### **Plan Change 60 - Maxwell Hills Zone – Reply to Request for Further Information**

**RESPONSE TO REQUEST FOR  
FURTHER INFORMATION  
RESOURCE CONSENT  
APPLICATION  
PLAN CHANGE 60 - MAXWELL  
HILLS ZONE**

The following responses, prepared by Riley Consultants Ltd (RILEY), relate to questions raised by Mr Paul Whyte of Beca Carter Hollings & Ferner Ltd (Beca) on behalf of the Marlborough District Council (MDC), in their letter dated 10 June 2011, requesting further information.

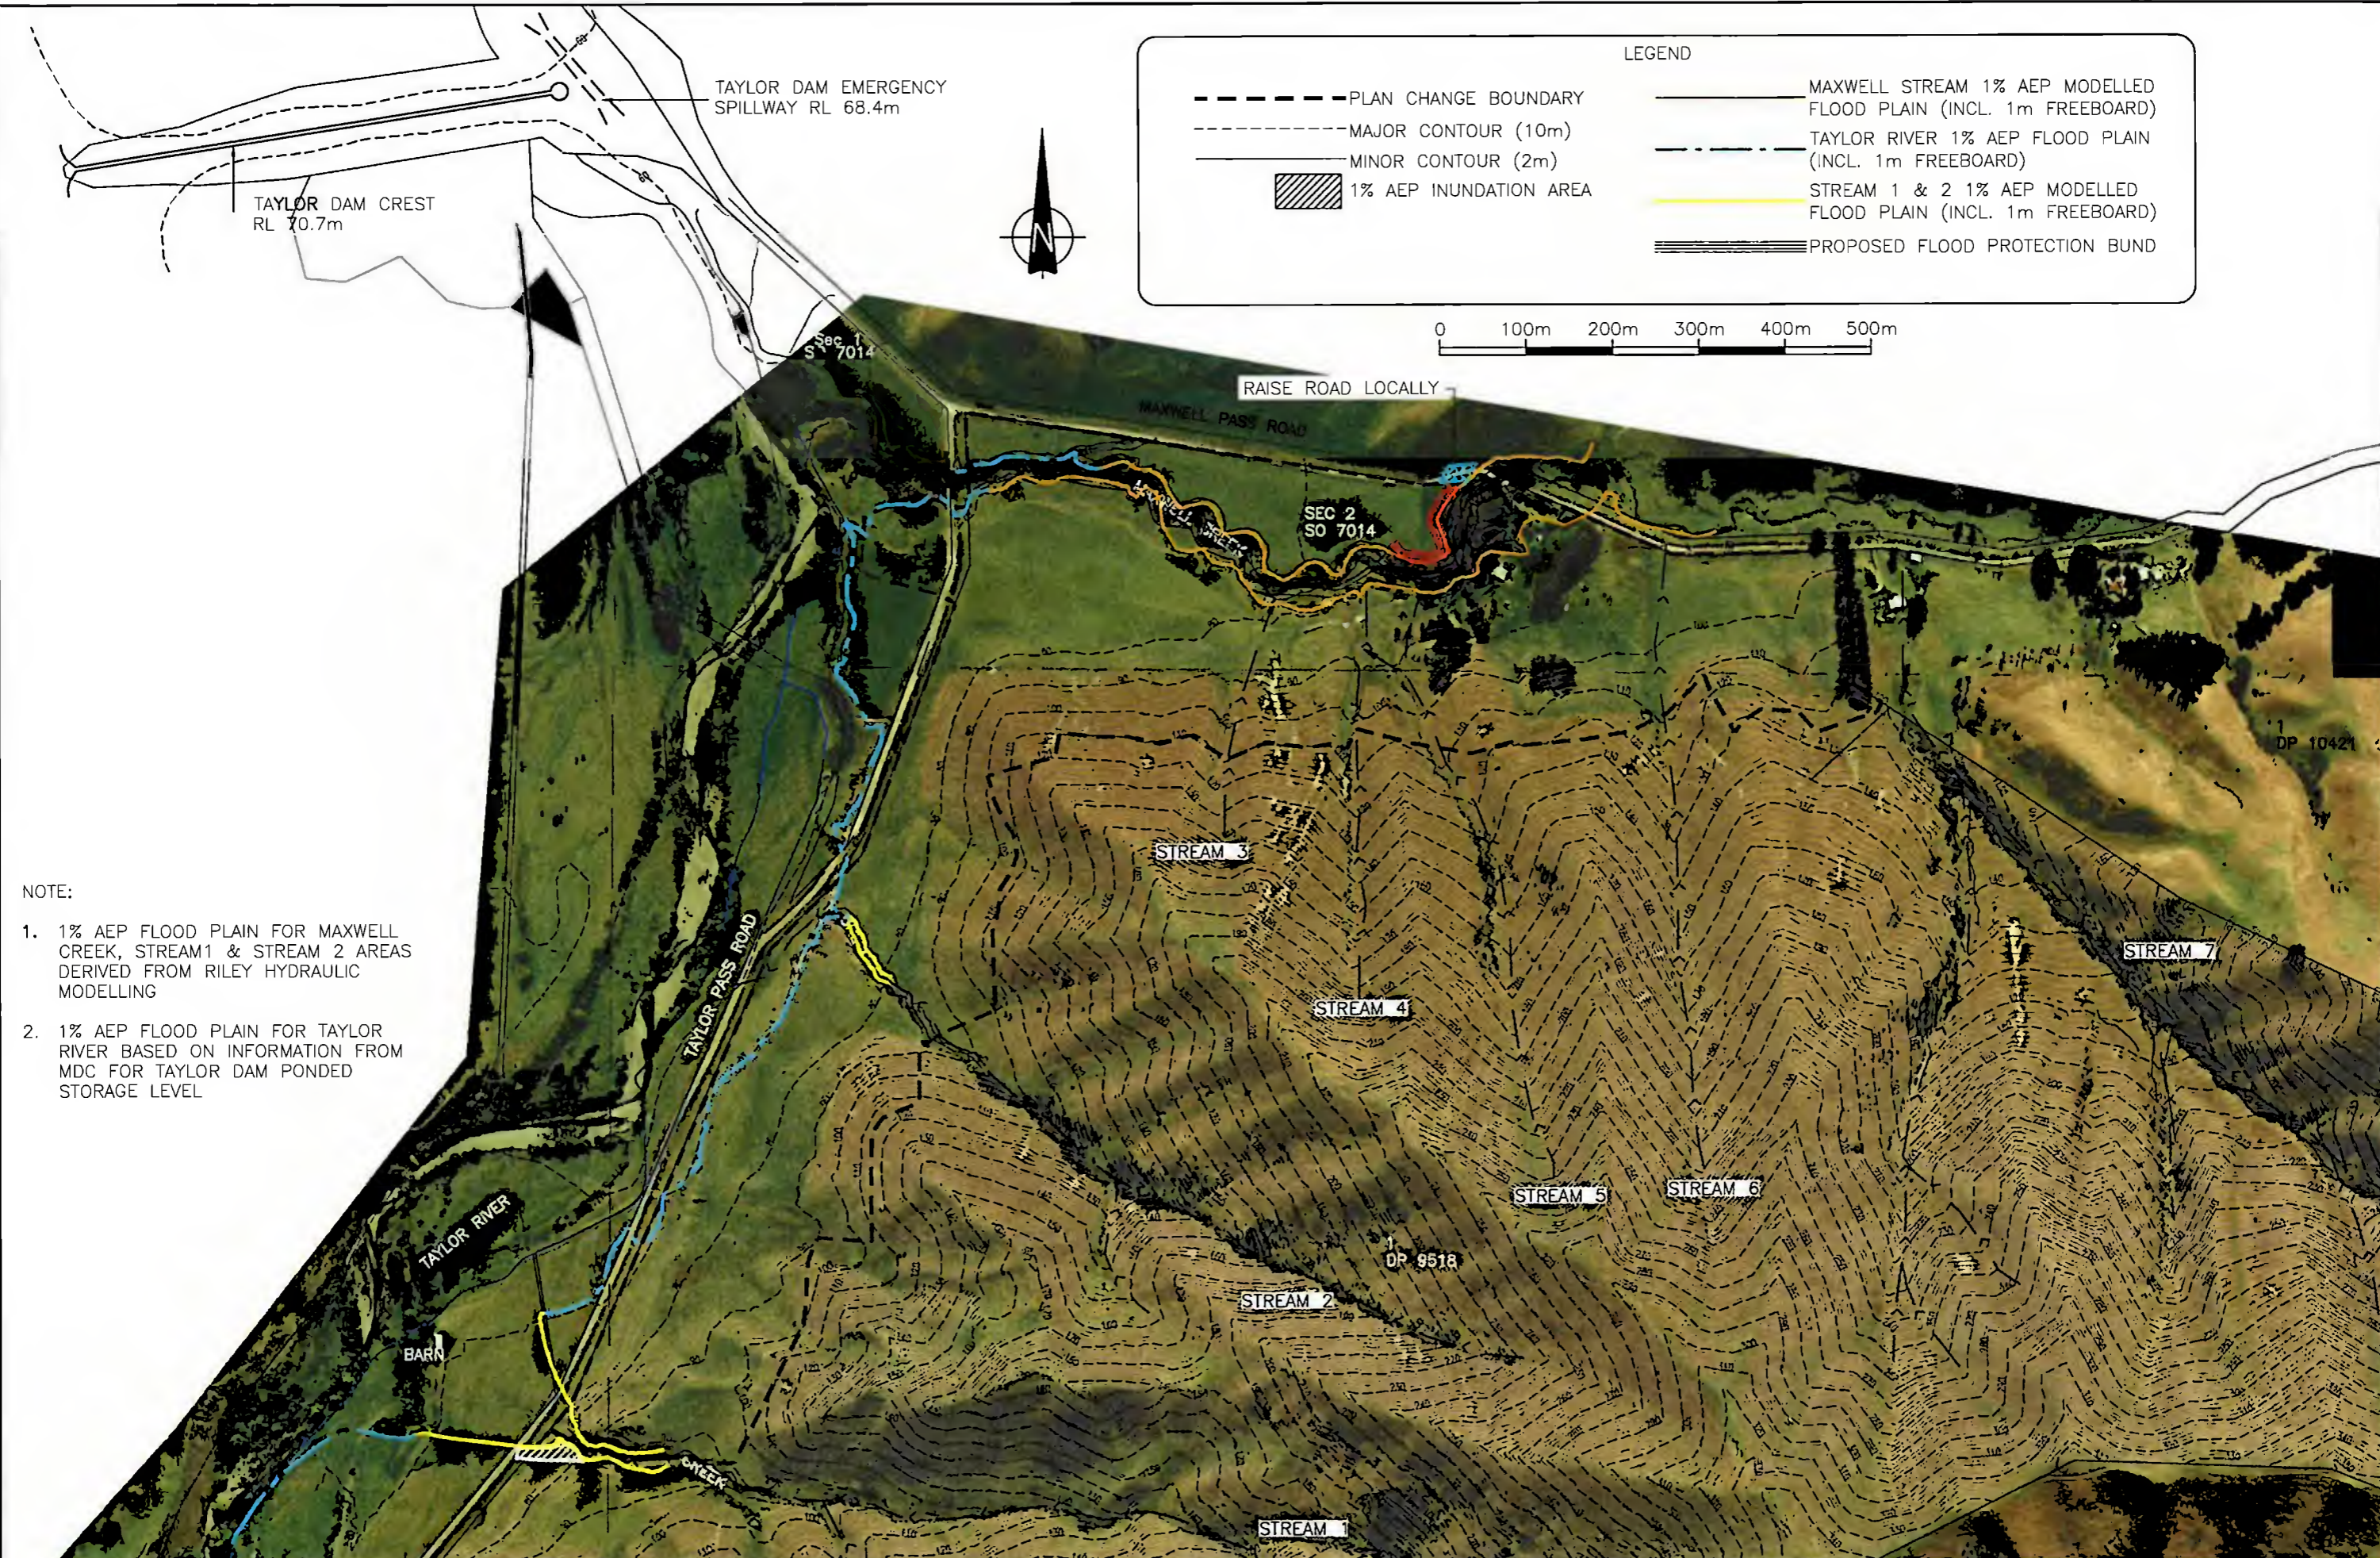
### **Reply to Additional Comments from Mr Brin Williman**

The flood assessment map RILEY Dwg: 04819/6FL-1 has been amended to include the Taylor Dam, with reference to its crest level (RL 70.7m) and the emergency spillway (RL 68.4m). The 1% AEP flood plain level as provided by MDC (Mr Brin Williman) is shown as a blue line extending alongside the Taylor River and into the proposed plan change area (i.e. it crosses Taylor Pass Road onto the lower parts of the proposed plan change area). The flood plain also extends up into the Maxwell Creek tributary, merging with the modelled 1% AEP flood plain of the creek. A direct analysis of the Taylor River flood levels was not undertaken as the section of river near the site is controlled by the Taylor Dam. As previously mentioned, all flood plain levels include an additional 1m freeboard. Two further drawings have been amended and included to show proposed minimum FFLs adjacent to the Taylor River and Maxwell Creek, RILEY Dwgs: 04819/6FL-2 and 3. Note the FFLs are the same as the adjacent 1% AEP flood level line (including 1m freeboard).

CADFILE	04819_6FL-2&3
SCALES (A3)	1:2500
DRAWING No.	04819/6FL-2
REV.	1

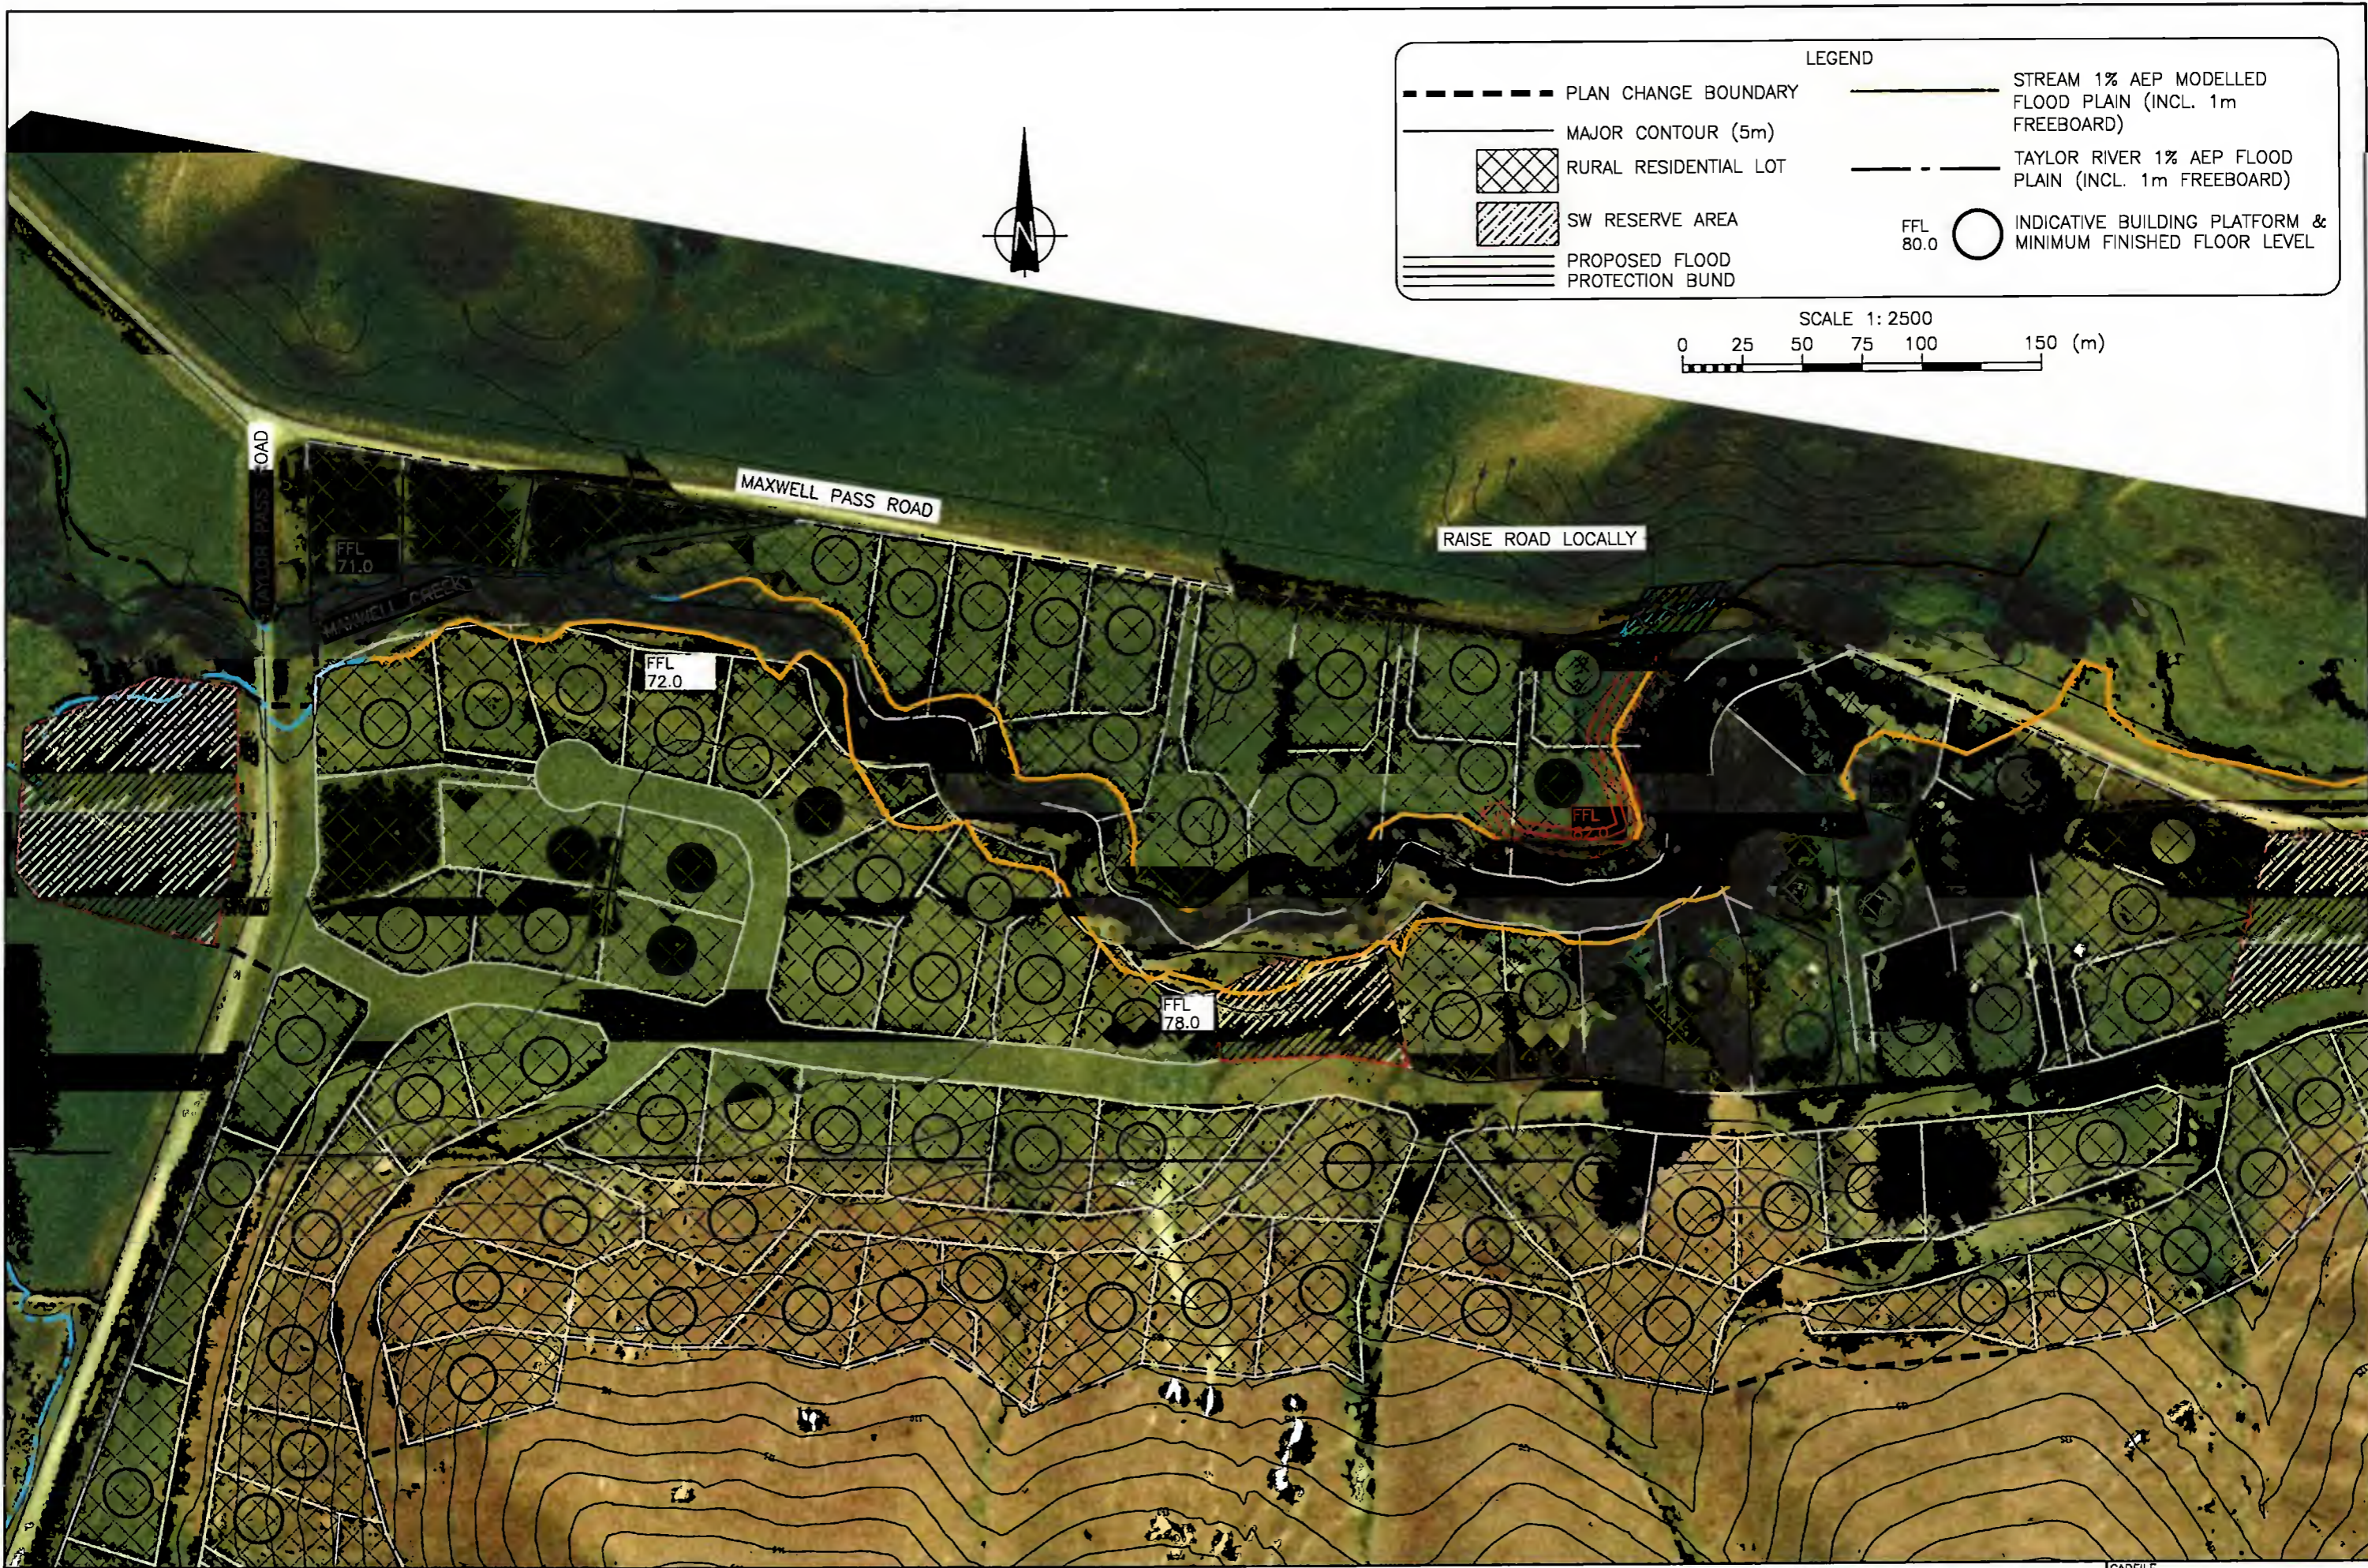
#### **Question 4.4 - Flood Inundation and Protection**

The extent of the estimated 1% AEP Floodplain (including 1 metre freeboard) is shown on RILEY Dwgs: 04819/6FL-1 to 3 (Appendix A). As mentioned earlier, minimum FFLs have also been added to show flood levels along the creek/river.

RILEY Dwgs: 04819/6FL-1 and 2 have been updated and Dwg: 04819/6FL-3 added to better clarify the design flood plain for the Maxwell Creek, Taylor River, Stream 1, and Stream 2. Additional contours have also been provided for clarification.
